Technical Service Bulletin

AIR BAG WARNING WITH DTC B1126:13 OR B1127:13

Bulletin No.: 08-002/22

Last Issued : 09/13/2022

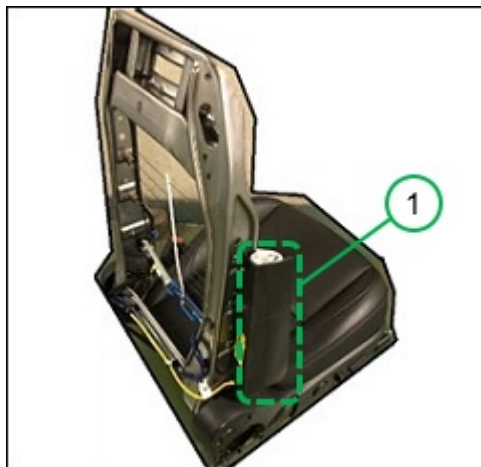
Some vehicles may exhibit that the air bag warning light turns on or repeats cycles of turning on and off with DTC B1126:13 and/or B1127:13 stored in memory.

- When the driver or passenger moves, a load is applied to the seat back and the load may cause displacement of the mating terminals in the side air bag module connector, resulting in insufficient contact and higher resistance.
- The DTC detection level is too sensitive.

- The design of the connector terminals in the side air bag module has been modified for firmer contact.
- The DTC detection level of the SAS control module has been optimized.

1. Verify the customer concern.
2. **[For 2020-2022 CX30 with VINs lower than 3MVDM*****414338 (produced before Feb. 27, 2022)]** Replace the affected side of the side air bag module(s) (1) with modified one(s) according to instructions on MGSS.
 - US/Canada spec: (SIDE AIR BAG MODULE REMOVAL/INSTALLATION [TWO-STEP DEPLOYMENT CONTROL SYSTEM - US/CANADA SPEC.]).
